RE: Pontilux - 1301 Cuesta Abajo Ct NE

Grading and Drainage Plan

Hydrology File: D13D002H

Based upon the information provided in your submittal received 4/7/2017, the Grading and Drainage Plan **is not** approved for Grading Permit. The following comments need to be addressed for approval of the above referenced project:

# GRADING AND DRAINAGE PLAN

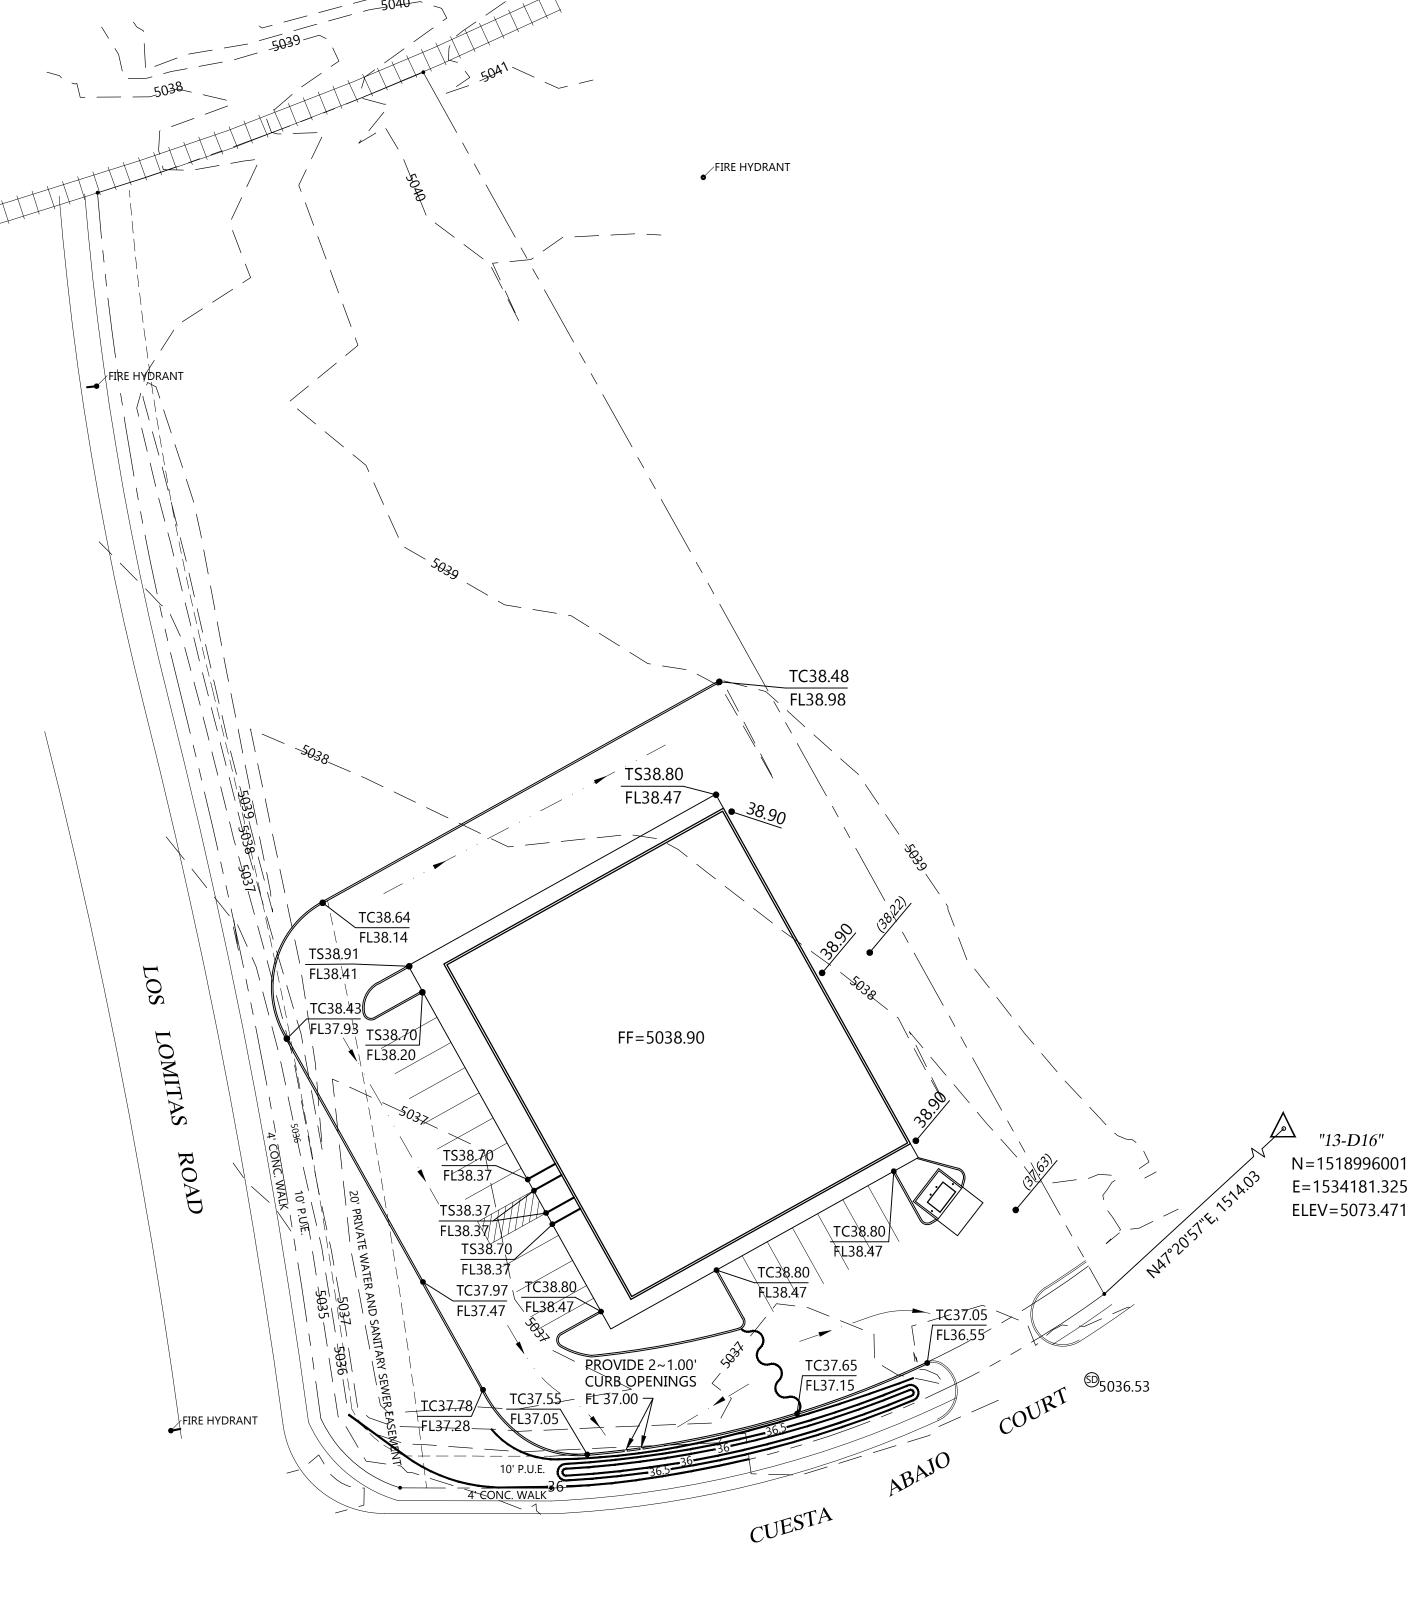
- 1. This site is part of a Master Drainage Plan by Mark Goodwin and Associates engineer's stamp date of 1/18/05. Please address this in the drainage narrative for the existing conditions.

- 2. As part of this Master Drainage Plan, there is a maximum allowable Q that is allowed for this tract. Please note that the proposed Q is below this. Please add this maximum allowable Q in the drainage narrative.

- 3. Under your drainage calculations, the existing conditions needs show the existing asphalt in the shared access easement. Also, the proposed conditions needs to address this existing asphalt as well.

- 4. Please add the following information to the Grading Plan:
  - a. Shared access agreement along the east property line.
  - b. Existing pavement and grades on this pavement.

- c. Existing 100 ft easement along the north property line.
  - d. Existing inlets on Cuesta Abajo Ct. There are four of them adjacent to the property. Please include the TC and FL elevations.

- e. Existing TC and FL of the existing driveway curbing.
- f. Please label/hatch the existing curb along Los Lomitas Rd. It disappears in all of the line work.
- g. Please label/hatch the proposed curb along Cuesta Abajo. It disappears in all of the line work.
- h. Please show the existing ramps at the corner of Los Lomitas & Cuesta Abajo and the existing driveway.
- i. Please label/hatch the existing berm along Los Lomitas.
- j. Please label or put in the legend the water block/high point.
- 5. Please add a water block/high point symbol at the NW corner of the propose pavement.

6. The propose pavement is cutting into the existing berm. This berm was placed per the Master Drainage Plan along Los Lomitas to divert the site drainage towards the inlets on Cuesta Abajo. Please show how you are going to continue this drainage pattern. Such as re-contouring the berm behind the proposed curb so no drainage will spill onto Los Lomitas.
